Determination 2016/048

Regarding the requirements under section 112 to remediate the fire separation between units in an apartment complex, and the compliance of the proposed solution at 287 – 289 Shirley Road, Papatoetoe, Auckland

Figure 3: cross section of intertenancy wall (not to scale)

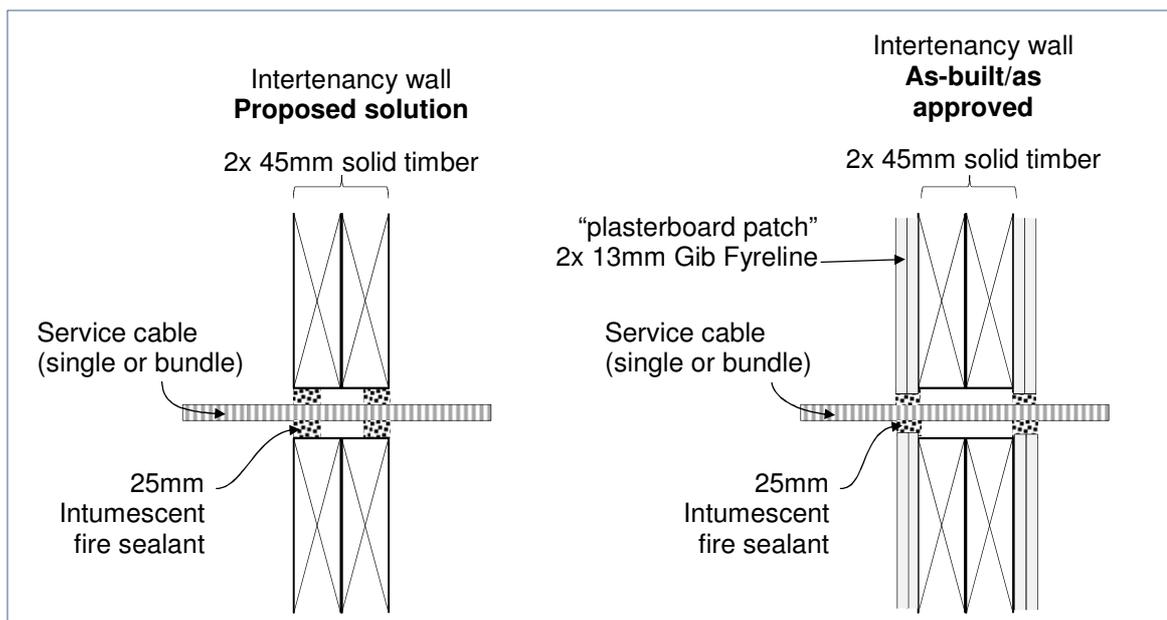
2.5.1 The authority responded on 30 June 2015, stating that it considered the proposed solution was not acceptable because no testing had been done of intumescent fire sealant protection applied directly to timber framing, and in its view ‘a 150 x 150 mm [plasterboard] patch would meet the [plasterboard manufacturer’s manual] where details show plaster board extending 75mm out from a penetration.’ (From the photos of the cable penetrations provided by the applicant, many penetrations are close to the edge of timber member concerned, and the 75mm extension sought by the authority is not able to be achieved.) Refer to figure 3 below:

Authority
A number of penetrations are for bundles that exceed 3 cables. Thicker cables and cable bundles would require special sealing system in place and specialist input to establish the compliance of the solution. Based on inspections, it would be unlikely that the maximum cable bundle (which may be 10 or 12) would occur in every unit.
The approved solution addresses the bundles but the proposed solution does not.
Applicants' consultant
The maximum number of cables in a penetration is 12. The representative penetration would be one cable, though there will be instances where there are bundles. The main cables are: power from distribution board cupboard (the number of power cables reduces as it goes through the block); and gate control cable (which runs right the way through the block). A number of cables don't penetrate all the way through to the adjacent unit but go up into the floor above, remaining within the unit (not shown in fig. 3).

- 6.8.1 At the hearing the consulting expert provided further information and clarification regarding the performance of the proposed solution in the event of a fire. In a later review of figure 3 (paragraph 2.5.1), the consulting expert indicated the proposed solution applying to penetrations of 1 to 3 cables only.

- the proposed solution, as described in figure 3 of this determination, would comply with Clause C3.3 of the Building Code for penetrations where there are up to three cables in a bundle
- there is insufficient evidence to form a view as to compliance of the proposed solution with Clause C3.3 in regards to penetrations where there are over three cables in a bundle.
